# UNITED STATES PATENT AND TRADEMARK OFFICE

APPLICATION NO.	FILING DATE	FIRST NAMED INVENTOR	ATTORNEY DOCKET NO.	CONFIRMATION NO.
10/664,371	09/17/2003	Jorge L. Orbay	JGPAT03a03US	4572
36822	7590	01/25/2008		
GORDON & JACOBSON, P.C. 60 LONG RIDGE ROAD SUITE 407 STAMFORD, CT 06902			EXAMINER RAMANA, ANURADHA	
			ART UNIT	PAPER NUMBER
			3733	
			MAIL DATE	DELIVERY MODE
			01/25/2008	PAPER

## Office Action Summary

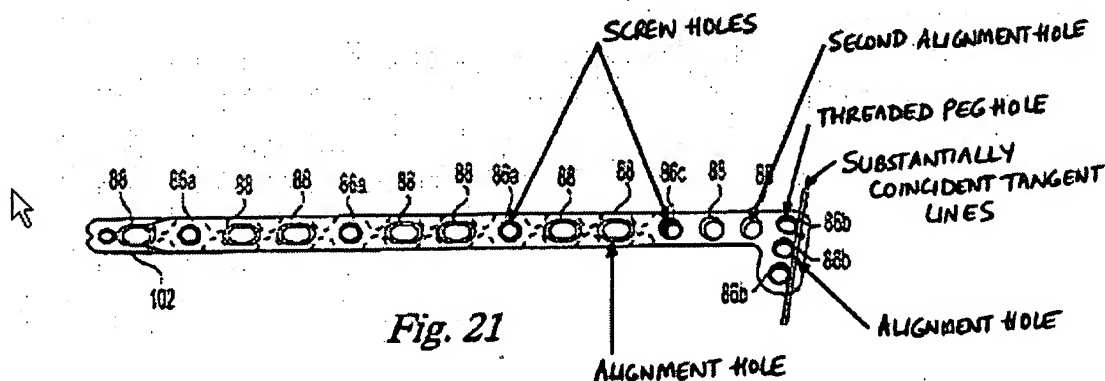
Claims 37-38, 45-48, 51 and 53-55 are rejected under 35 U.S.C. 102(e) as being anticipated by Weaver et al. (US 6,623,486).

Weaver et al. disclose a bone fixation plate 80 including: a head angled relative to a the shaft; the head portion defining a first set of threaded holes 86b; alignment holes much smaller in diameter than the threaded holes for provisional fixation of the bone plate; a second alignment hole 88; and a plurality of screw holes 86a in the shaft of the bone plate (Figs. 20-26, col. 6, lines 58-67 and col. 7, lines 1-17). See marked up Fig. 21 from Weaver et al. below.

Regarding claim 48, Weaver et al. clearly disclose a shaft having a plurality of holes or "screw holes" with alignment holes (either 88 or 86a) that are configured to receive a K-wire that could be oblique relative to the bone contacting surface of the plate depending on the angle of insertion, i.e., predetermined fixed axial orientation.

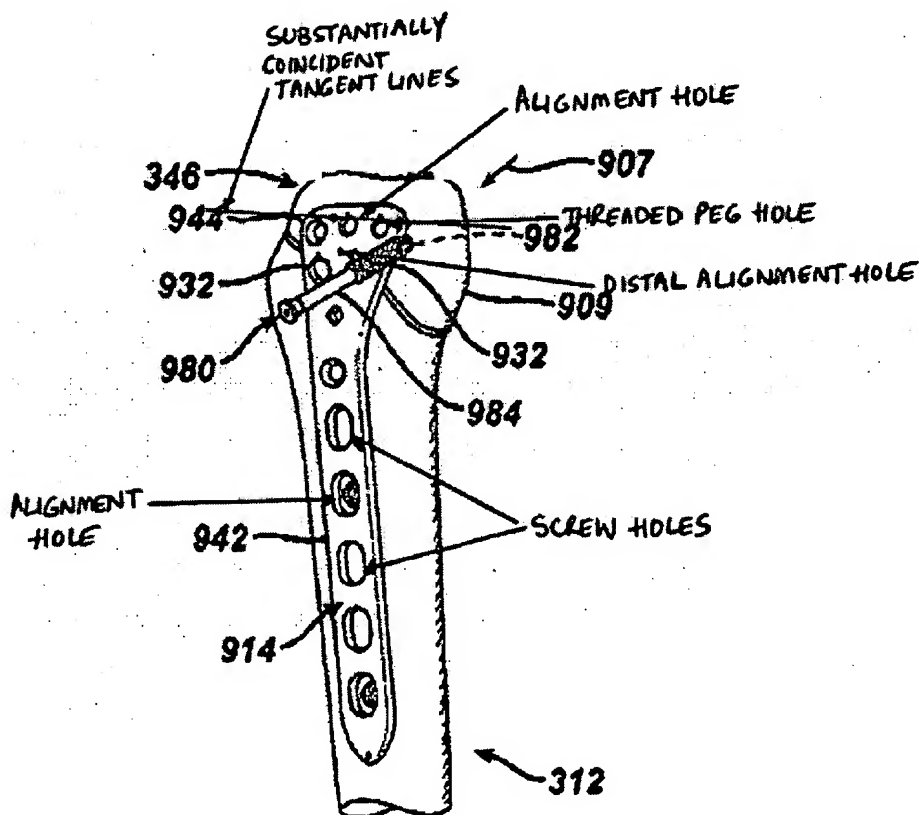
Claims 37-38, 40-43, 45-46, 48-51, 53-55, 58-59 and 65-69 are rejected under 35 U.S.C. 102(e) as being anticipated by Wack et al. (US 2004/0030339 A1).

Wack et al. disclose a plate 914 defining a first set of peg holes structurally adapted to engage a threaded head of a fixation peg and at least one non-threaded alignment hole 871 having a second relatively small diameter wherein the first alignment hole defines a tangent line substantially coincident with a line tangent to the first set of threaded (Figs. 20-22 and paras [0118]-[0162]). See a portion of Fig. 20 marked up to show features of Applicant's invention below.

Contrary to Applicant's arguments with respect to claim 37, Wack et al. clearly disclose alignment holes that are proximally placed, i.e., "not displaced distally relative to a distal tangent line between two respective peg holes."

Regarding K-wire holes 871, the Examiner notes that the hole(s) is(are) capable of receiving K-wire(s) in a predetermined fixed axial orientation, i.e., direction of

insertion chosen by the surgeon, such that the K-wire(s) are oblique to a bone-contacting surface of the plate due to the angled head of the bone plate.
